ADDENDUM TO  
SPECIFICATIONS ENTITLED  
"SPECIFICATIONS FOR  
WARDLAW COLLEGE ROOF REPLACEMENT-RE-BID  
STATE PROJECT NO. 50003317-2  
WARDLAW COLLEGE  
COLLEGE OF EDUCATION  
820 SOUTH MAIN STREET  
COLUMBIA, SOUTH CAROLINA"

**ADDENDUM NO. 1**

**March 16, 2020**

## Unistrut Photographs

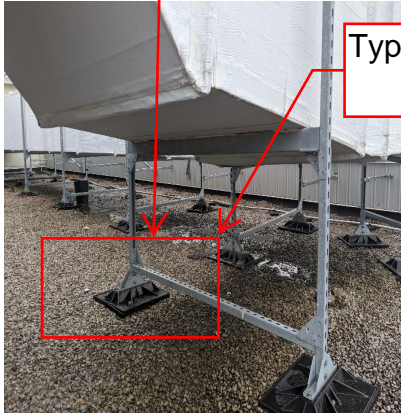
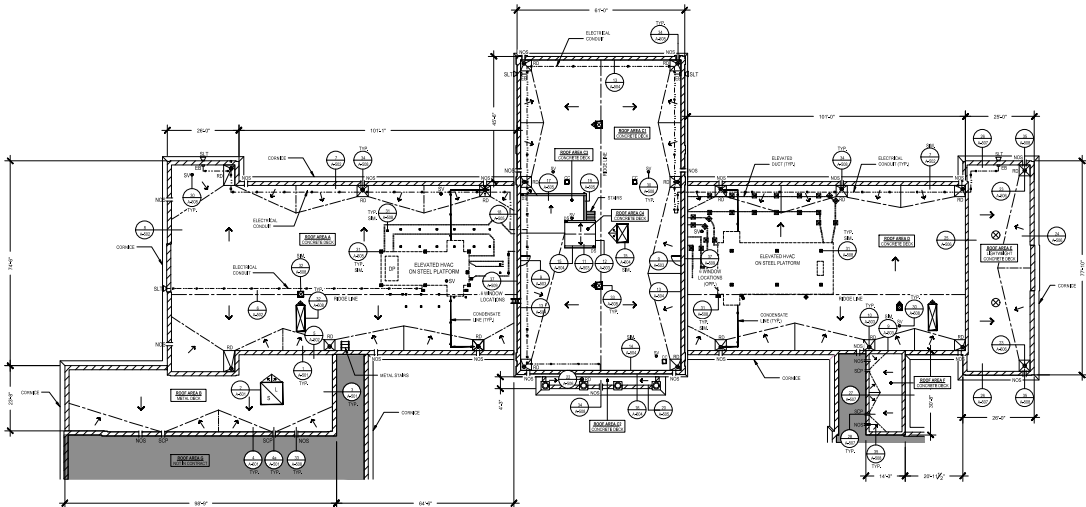
Bid Closing April 9, 2020 AT 2:30pm 1300 Pickens St. Room 100B, Columbia, 29208. All other terms and conditions remain unchanged.
2. Results were returned as Negative for Asbestos at the exterior stucco wall along Roof Area F. Asbestos test results are attached.
3. Unistrut's located at the HVAC unit on Roof Area A will need to be cut to allow removal of existing roof and installation of new roofing system. Once new roofing system is installed, Contractor is to install new supports at Unistrut's similar to the supports on Roof Area D. See attached photos.
  - a. Temporary supports will be required at both Roof Area A and D when demoing the existing roof to support HVAC duct work.

Typical unistrut support at Roof Area A, HVAC duct work. Supports similar to Roof Area D will need to be installed at Unistruts once roofing system is installed.

Typical unistrut support at Roof Area D.

**A-101**

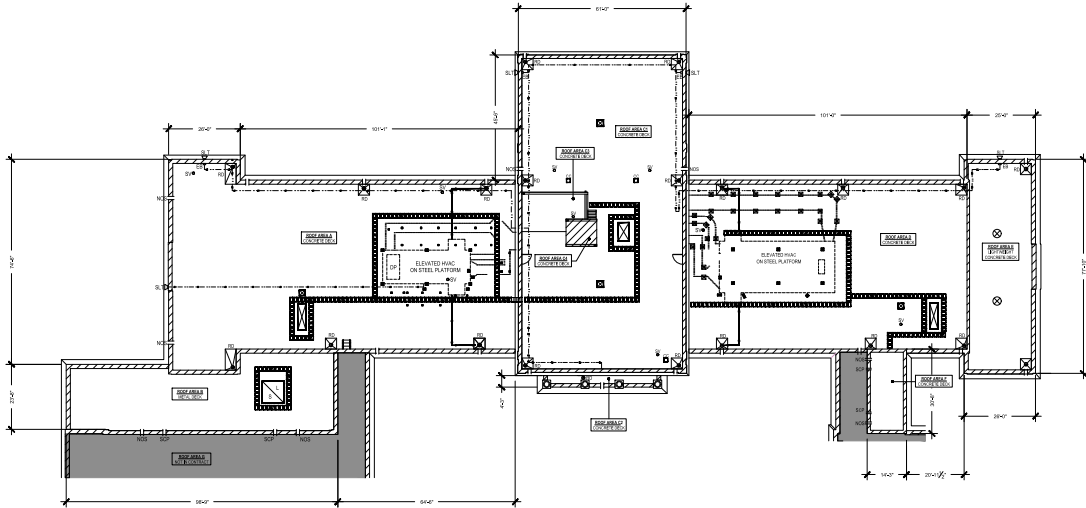
1. Delete Drawings G-101, A-101, A-102 and A-103 in their entirety and replace with attached Drawings G-101, A-101, A-102 and A-103 (Addendum No. 1)
